Symptom In Vehicle Interior - Outside Temperature Display Implausible: Reworking wire harness for outside temperature sensor (SY 38/18)

Model Line: **Macan (95B)**

Subject: **Outside temperature sensor**

Air guide flap (right)

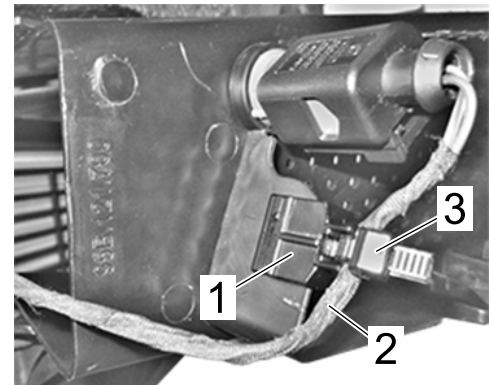
- Work Procedure: 1 **Preliminary work:**
- 1.1 Remove front apron.
 ⇒ *Workshop Manual '631519 Removing and installing front apron'*
 - 1.2 Swivel flap of the air guide (right) ⇒ *Air guide flap (right) -1-* forward.
